**Re: Notification of Data Availability and Request for Comment:
*Energy Conservation Program: Energy Conservation Standards for
Consumer Water Heaters, EERE-2017-BT-STD-0019, RIN 1904-AF65,
89 Fed. Reg. 59692 (July 23, 2024)***

The American Gas Association (“AGA”), American Public Gas Association (“APGA”), and National Propane Gas Association (“NPGA”) (collectively, “Joint Commenters”) respectfully submit these comments in response to the above-referenced proceeding regarding the notification of data availability and request for comment (“NODA”) pertaining to energy conservation standards for consumer water heaters issued by the U.S. Department of Energy (“DOE”).¹ Joint Commenters raise various material issues with the NODA, particularly the fact that DOE currently relies on data used in rules designed for other natural gas appliances and not gas-fired instantaneous water heaters (“GIWHs”). Due to these critical issues, DOE should restart the rulemaking process for GIWHs, or at minimum issue a supplemental notice, that contains analysis with the appropriate data and addresses the concerns discussed herein.

Figure 8D.3.2 Metal Venting Installation (Non-Condensing Gas-fired Water Heater and/or Non-Condensing Gas-fired Furnace)

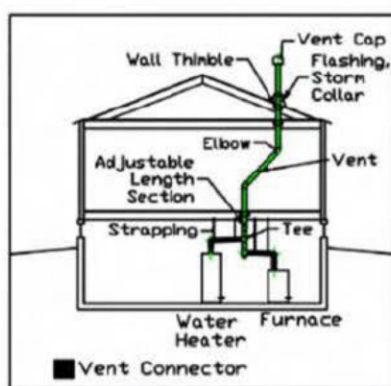
Venting Design as Described in DOE's TSD: Misalignment with Horizontal Installations (Figure 8D.3.3)

The DOE model identifies 86% of all GIWH installations in the 10,000 trials as horizontal, with the remaining 14% utilizing vertical vent designs like those used by non-condensing furnaces, typically spanning 10 to 20+ feet. However, the model likely overestimates the percentage of vertical installations for both new and replacement GIWH installations. The economic advantages of new non-condensing GIWH systems typically favor horizontal venting over the more complex and costly vertical Category I venting systems used by other water heaters. Fixing the overestimation of new GIWHs installed with vertical venting, especially long 20+ foot length installs, would reduce average Life Cycle Cost ("LCC") savings further.

Despite recognizing that 86% of installations are horizontal, the DOE model inaccurately applies the same labor and material costs to these installations as it does to vertical installations. This results in an overestimation of costs for horizontal installations, which are generally much simpler than vertical installations. The average horizontal system requires less than 7 feet of venting and follows a straightforward work plan, like that of a condensing unit. Such installations typically involve connecting just 3 or 4 individual parts through a wall, drastically simplifying the process compared to the more complex Category I vented storage water heaters or non-condensing furnaces.

The model assigns Efficiency Level 0 (“EL0”) to 30% of trials—of which about 10% involve vertical venting in the base case. For the horizontal EL0 GIWH installations, the model assumes the same labor and part requirements for vertical installations, failing to reflect the simplicity and lower cost of horizontal venting designs in general.

Figure 8D.3.3 Plastic PVC Installation (Condensing Example)

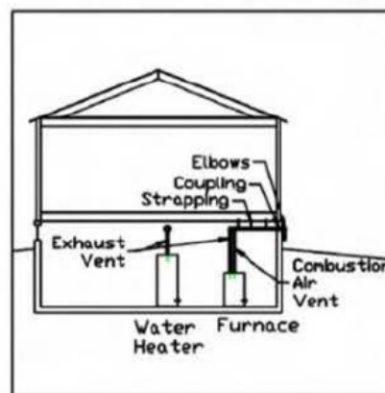
The discrepancy becomes evident when comparing this to the installation of a similar 2-foot pipe for a condensing GIWH, which the model estimates would only take 13 minutes to install—even though the process and complexity are nearly identical, as both involve short horizontal installations. This inconsistency in labor time estimates leads to an overestimation of labor costs for non-condensing GIWHs.
